April 18, 2019

DC Zoning Commission
District of Columbia
CASE NO.18-21

Exhibit I – Existing Overhead Utilities

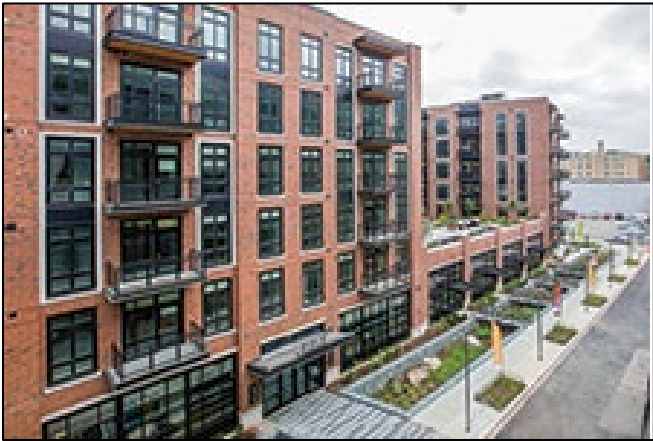
2. **Street Tree Coverage** - Many of the renderings provided by the development team include large mature shade trees along 8th Street. This would be a major long-term benefit to the existing 8th St. corridor, the environment, and could make 8th St. a great street for pedestrians and bikers. As shown in Exhibit I, the problem is the existing overhead electrical and telecommunications lines prevent any large shade trees from reaching full maturity/height in this location. For this reason, the overhead power lines should be undergrounded. If under-grounding all lines is cost prohibitive, undergrounding the telecommunications utilities alone would have a significant benefit.
